CITY OF ALBUQUERQUE

**RE: Coors Pavilion Replat
Conceptual Grading & Drainage Plan
Engineer's Stamp Date: No Stamp
Hydrology File: G11D069**

DESIGNED	JL
DRAWN	JL
CHECKED	SG
DATE	4.06.2020
RESPEC	
5971 JEFFERSON STREET SUITE 101 ALBUQUERQUE, NM 87109 ALBUQUERQUE WATER & NATURAL RESOURCES WWW.RESPEC.COM 505.253.9718	
REVISION	
STAMP	
PRELIMINARY NOT FOR CONSTRUCTION 4/2020	
THIS DRAWING IS INCOMPLETE AND NOT TO BE USED FOR CONSTRUCTION UNLESS IT IS STAMPED, SIGNED AND DATED	
nm811 Know what's below. Call before you dig.	
PROJECT NAME: COORS PAVILION LOTS 8 & 9	
SHEET TITLE: CONCEPTUAL GRADING & DRAINAGE PLAN FOR LOTS 8 & 9	
SUBMITTED FOR: DRB REVIEW	
SHEET NUMBER: C-1

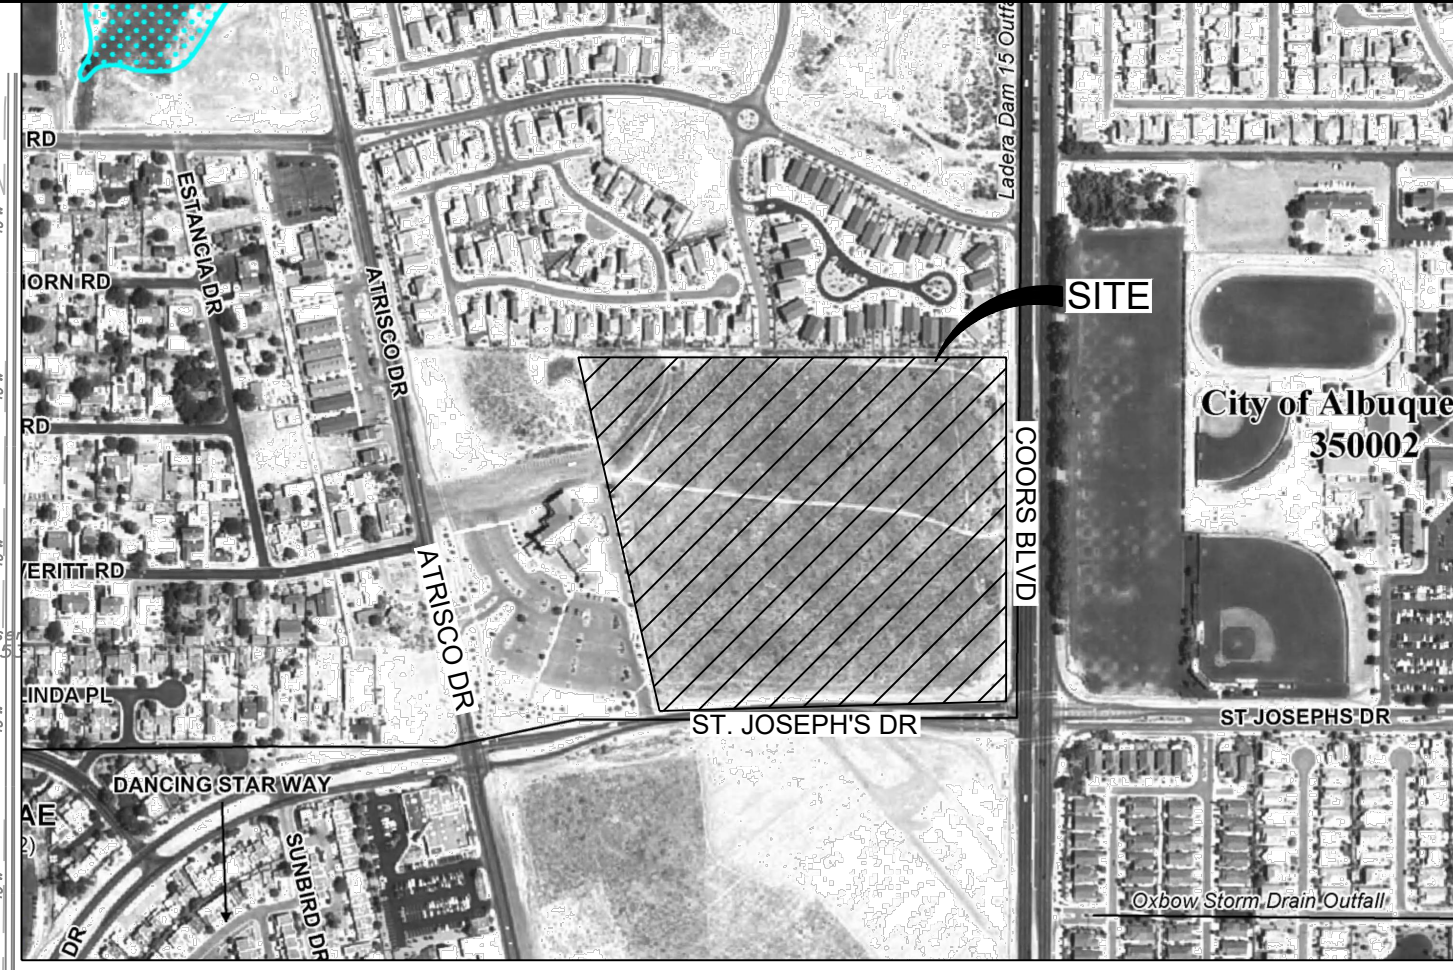
Based upon the information provided in your submittal received 11/19/2020, the Conceptual Grading & Drainage Plan **is not** approved for Grading Permit or for action by the DRB on Preliminary Plat. The following comments need to be addressed for approval of the above referenced project:

1. This plan needs to be a revised Master Drainage Plan. There current Master Drainage Plan as an approved engineering stamp date of 02/22/17. The following information needs to be shown on this revised Master Drainage Plan:
 - a. Please provide an engineer's stamp with a signature and date.
 - b. Please show all existing development including the access road that doubles as a drainage feature for these lots 1-6. These can easily be obtained on the City's GIS.

- c. Include project benchmark and datum.
 - d. Please provide the legal description of the property.
 - e. Please provide language outlining cross lot drainage easements specifying the beneficiary and maintenance agreement.
 - f. Please provide the hydrologic routing for the pond to ensure that it is sized correctly and functions as it was initially designed using either AHYMO S4, HEC-HMS or any other City approved program.
2. If this is also to be used for grading the new detention pond, a more detailed Grading & Drainage Plan for the new pond needs to be submitted.
 3. Standard review fee of \$300 (for DRB Site) will be required at the time of resubmittal.
